# Nomad

# SERVICE BULLETIN

SUBJECT: REMOVAL OF MAIN LANDING GEAR FLIPPER DOORS (MOD N373)

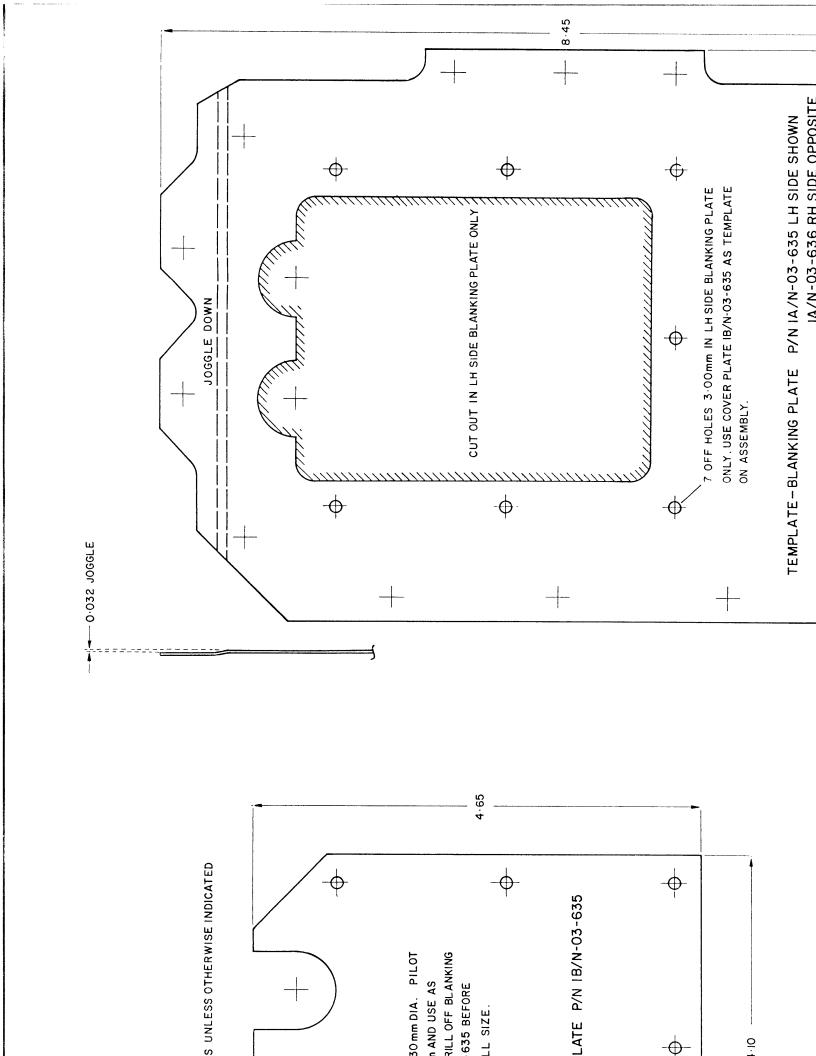
- (1) Manufacture two blanking plates and one cover plate using Figure 1 as a template. Joggle the blanking plates opposite ways so that the two panels become LH and RH respectively. Still using Figure 1 as a template, remove the metal from the area shown, in the LH plate only.

- (2) Mark out and pilot drill 2.5 mm dia fourteen off rivet holes in each blanking plate but not the seven screw holes in the LH blanking plate. Pilot drill 2.5 mm dia the seven screw holes in the cover plate.

Blanking and Cover Plate LH Side Installation Figure 2

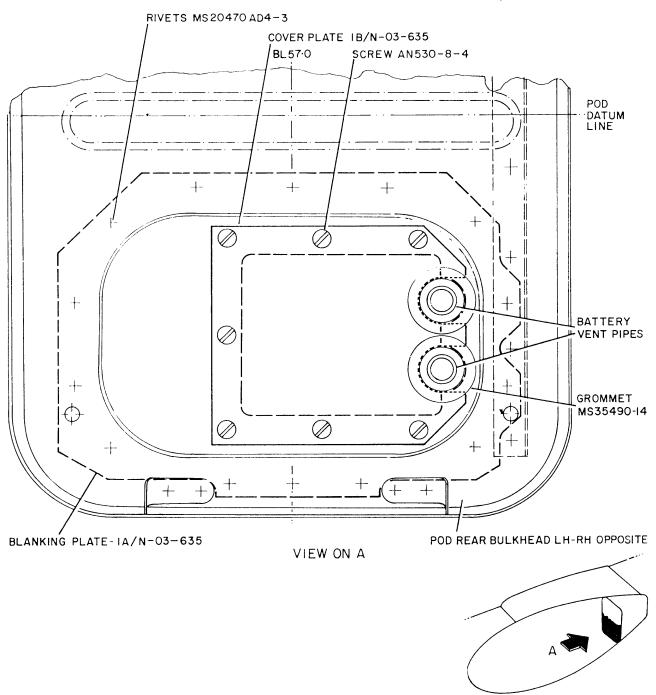
- (6) LH POD ONLY Locate the grommets onto the battery vent pipes and position the vent pipes through the cut-out in the blanking plates. Locate the cover plate onto the blanking plates, positioning it so that the cut-out traps the grommets in position (Ref Figure 2). Drill the seven pilot holes through the cover plate into the blanking plate. Remove the cover plate, open up the seven holes in the cover plate to 4.30 mm dia.

- (10) Locate the grommets installed on the vent pipes into position on the blanking plates on the LH rear bulkhead. Wet assemble the cover plate to the blanking plates using PR1221B or PR1222B sealing compound, ensuring that the grommets are trapped in position (Ref Figure 2) then secure the cover plate using self-tapping screws AN530-8-4.
